# Broadcast Products Technical Bulletin 20-2003-143

DATE: **July 7, 2003**SUBJECT: **REUSE IC1 WHEN REPLACING GA BOARD**MODEL: ***BVM-1411P***  
***BVM-1415C***  
***BVM-1415P***  
***BVM-2011P***  
***BVM-2015P***SERIAL NO: **ALL**

**Figure 1**

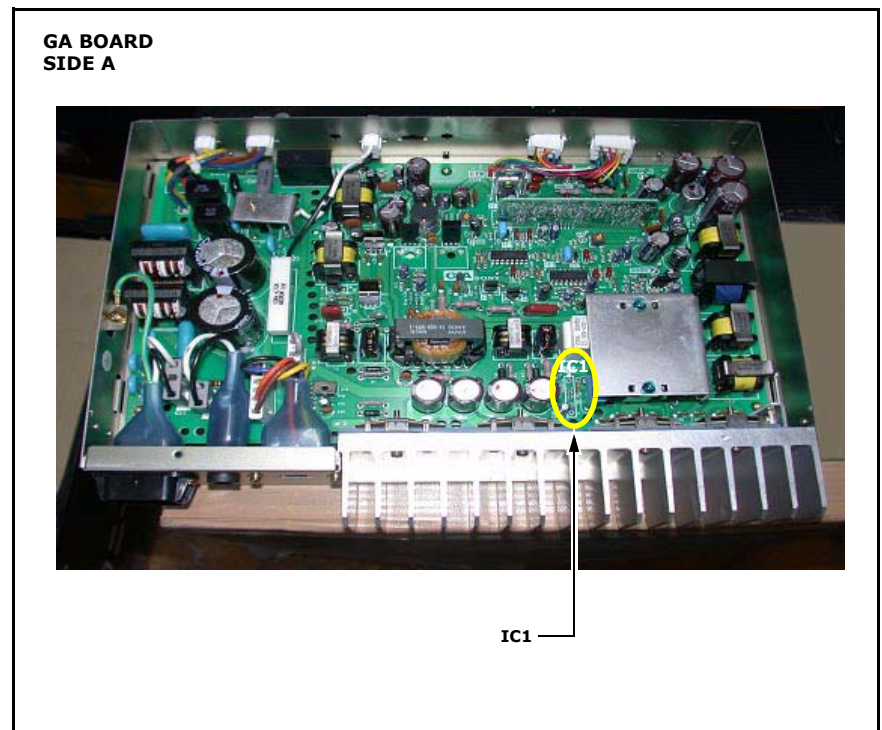
The new GA board does not contain IC1, and IC1 is no longer available as a service part. (See Figure 1.)

When replacing the GA board (A-1316-090-A), remove IC1 (1-806-805-11) from the former board and solder it to the new board.
